Detailed Site Plan DSP-20053-02
Departure from Design Standards DPT-2025-0003
West Hyattsville Phase 2 - ETOD

STAFF REPORT

SUBJECT: Detailed Site Plan DSP-20053-02
Departure from Design Standards DPT-2025-0003
Type 2 Tree Conservation Plan TCP2-2025-0074
Alternative Compliance ACL-2025-0008
Expedited Transit-Oriented Development (ETOD) Project
West Hyattsville Phase 2

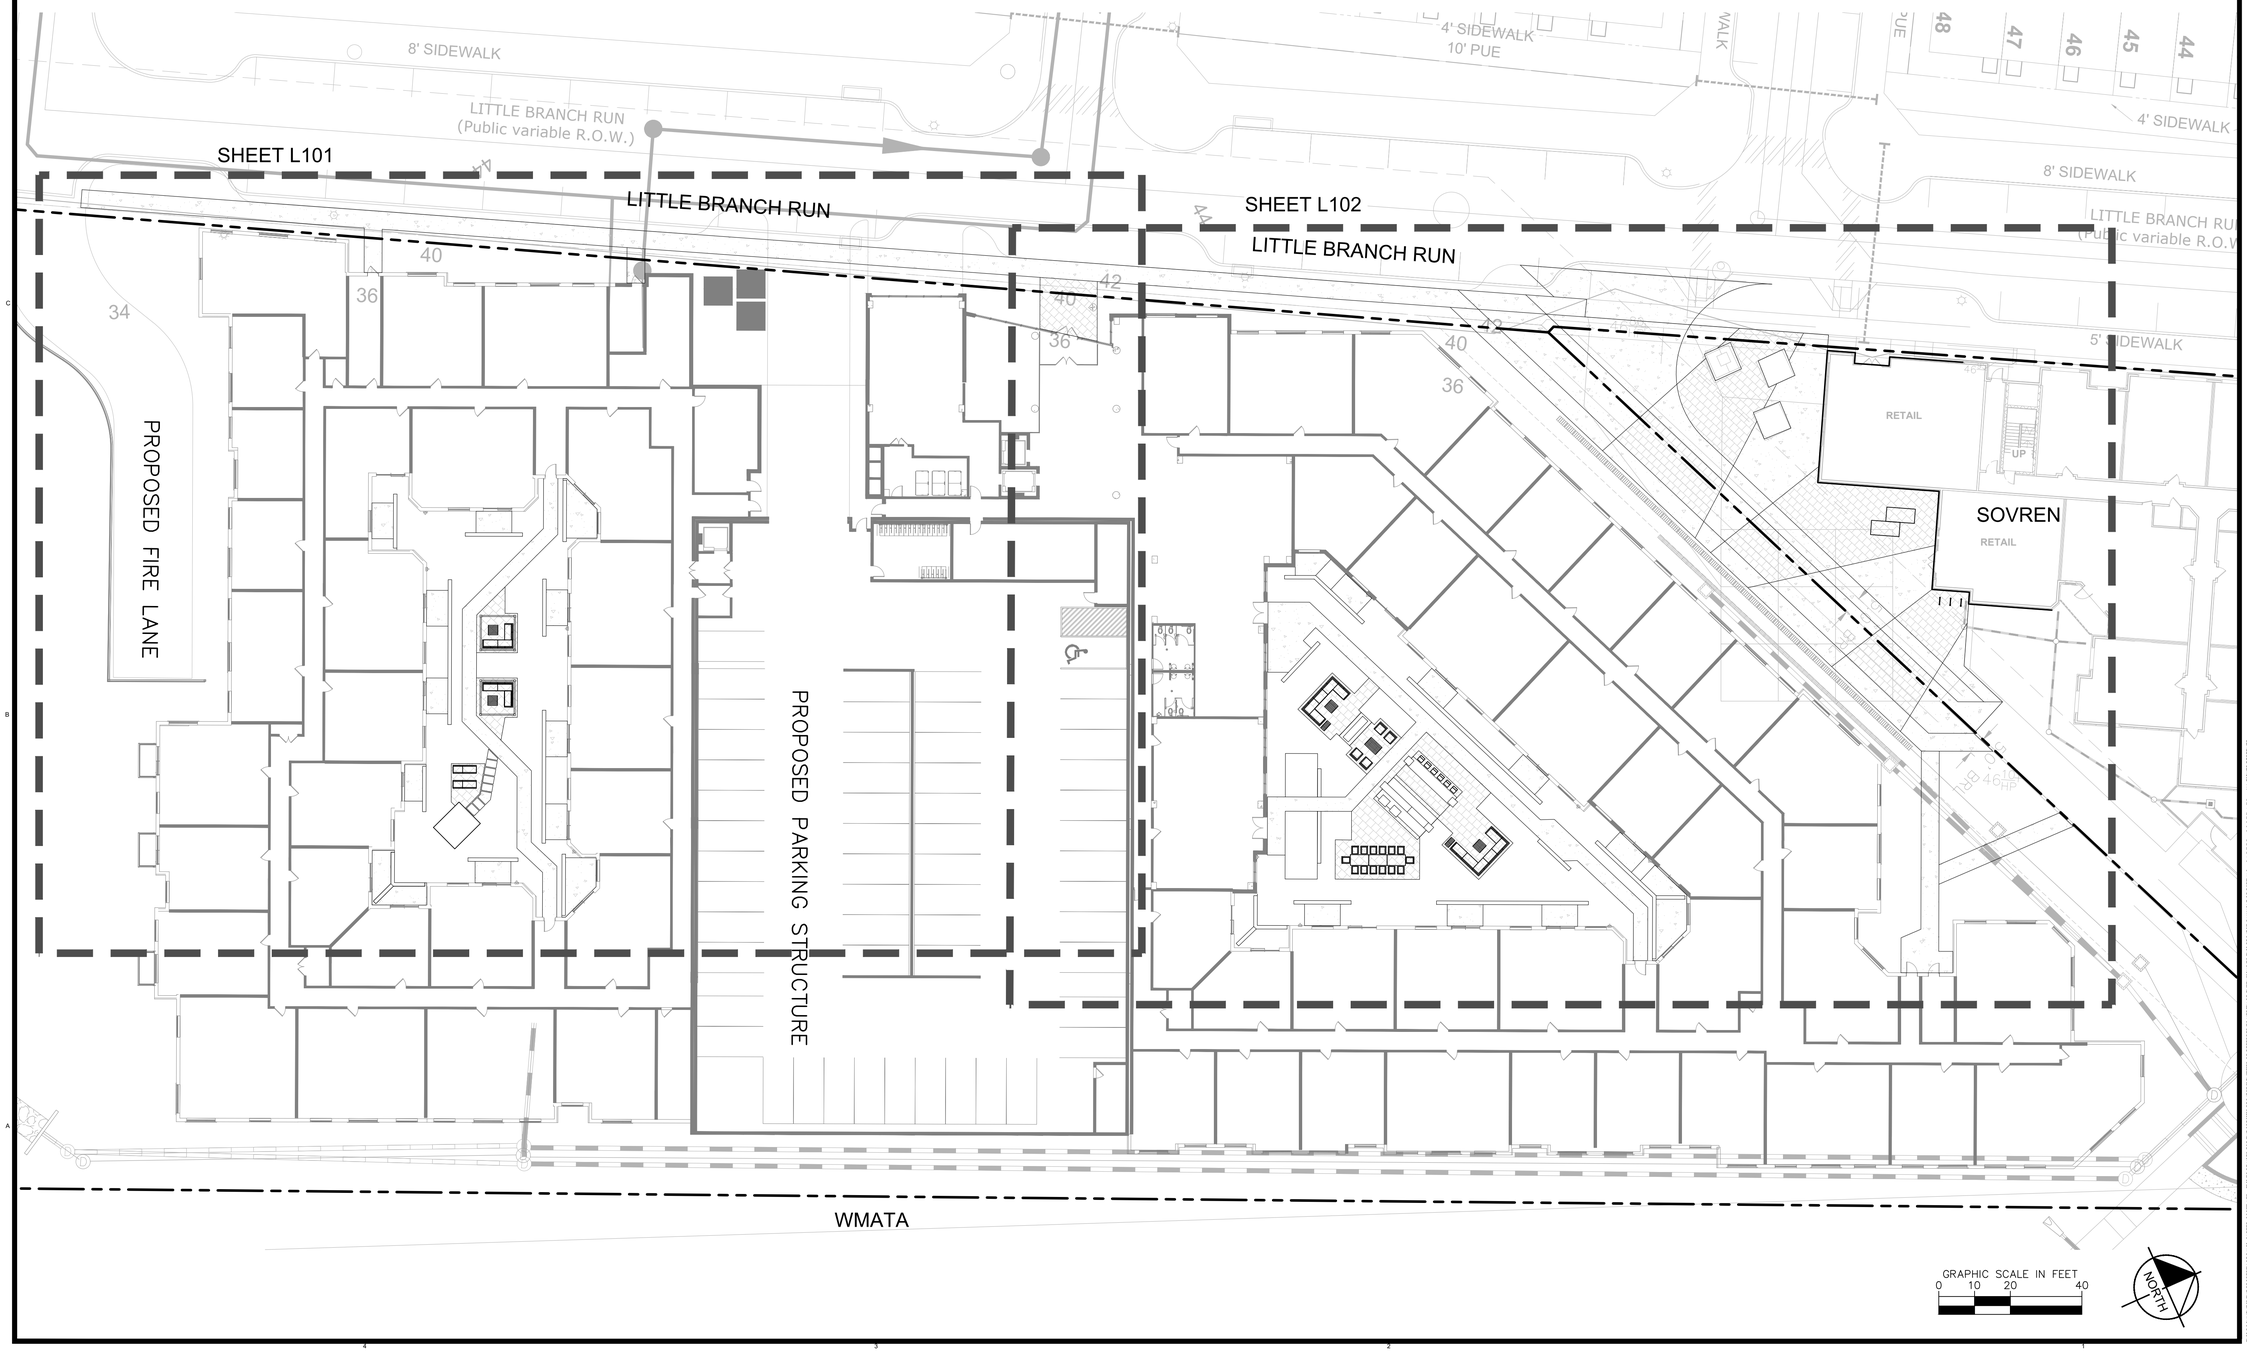
Comment: The extension of the 5-foot-wide sidewalks along the subject property's frontage of Little Branch Run until the point of vehicle entry for Parcel 2 and to the Northwest Branch Trail is identified on sheets 3 and 4. The bicycle parking in the parking garage for residential uses and on-site or in the right-of-way for nonresidential uses that is consistent with 2006 *Approved Transit District Development Plan and Transit District Overlay Zone* standards and bicycle fix-it station proposed within the garage is identified on sheet 4. Continental style crosswalks crossing the garage and loading zone access points are identified on sheet 4. The pedestrian and bicycle shared-use path through the property from the western side of the subject site near Emerald Branch Drive to the pedestrian tunnel to the West Hyattsville Metro Station is identified on sheets 3 and 4. This condition has been met.

Comment: While the West Hyattsville Metro Connector Trail is not a master planned facility, the site plan identifies the existing eight-foot-wide shared use path along eastern side of subject property, on sheet 3. The shared use path will provide connections from West Hyattsville Metro to the subject property.

side of subject property on sheet 4. The sidewalk provides connections from Northwest Branch Trail to the subject property.

Comment: While the Riverfront Connector is not a master planned facility, the site plan identifies this as a five-foot-wide sidewalk that connects with the Northwest Branch Trail along the southern portion of the subject property, shown on sheet 4.

Comment: The site plan includes a five-foot-wide sidewalk along the frontage of Little Branch Run and an eight-foot-wide sidewalk along the eastern side of subject property on sheets 3 and 4. A shared-use path is also provided through the property from the western side of the subject site near Emerald Branch Drive to the pedestrian tunnel for the West Hyattsville Metro Station, shown on sheets 3 and 4. Staff recommend ADA curb ramps at vehicular crossings. These facilities meet the intent of the policy.

Comment: The site plan includes a shared-use path through the property from the western side of the subject site near Emerald Branch Drive to the pedestrian tunnel to the West Hyattsville Metro Station, shown on sheets 3 and 4. These facilities meet the intent of the policy.

A301

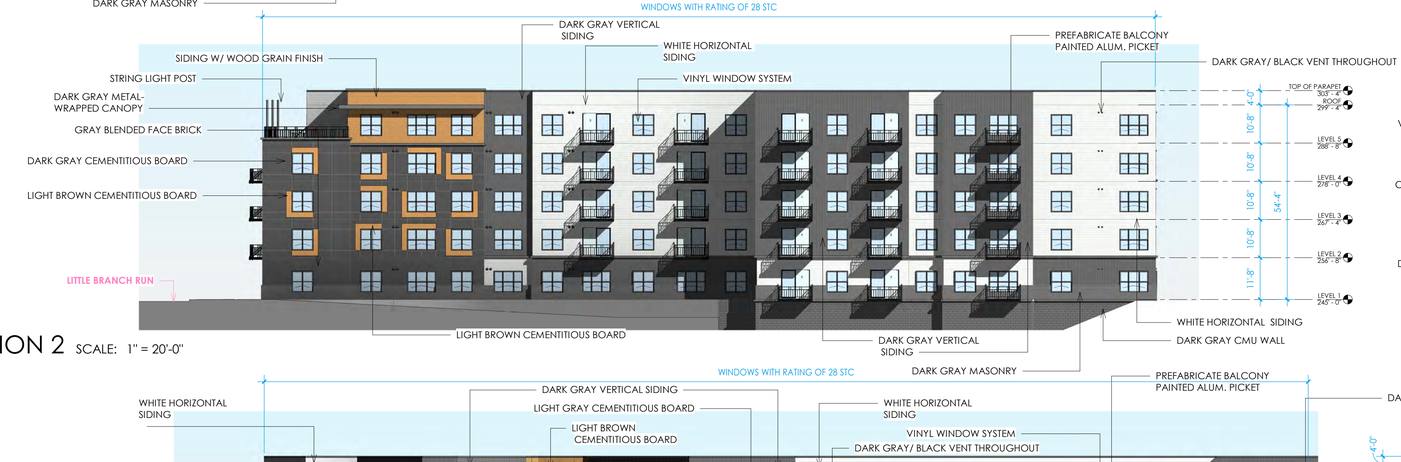
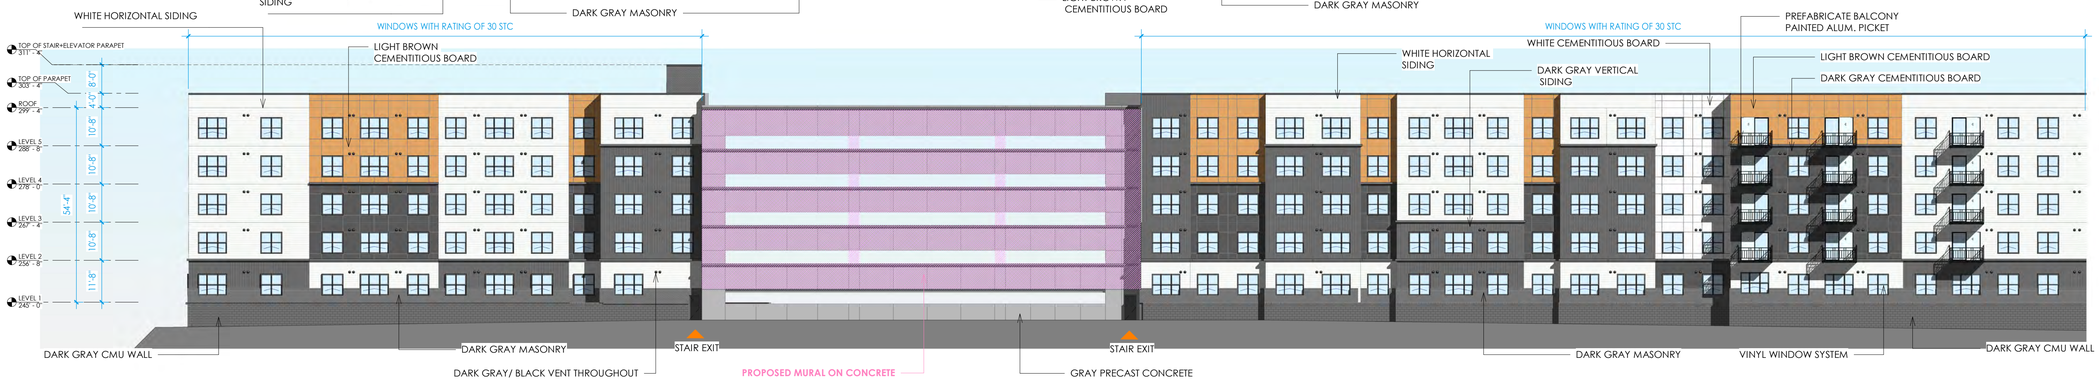
5. Buildings shall be designed to orient views towards the street and public realm.	The building is designed to orient views towards the public realm, with the front along Little Branch Run featuring balconies (see Drawing A301) that offer views of the street and surrounding public spaces. This approach enhances the connection between the building and its environment, fostering a stronger relationship with the community.
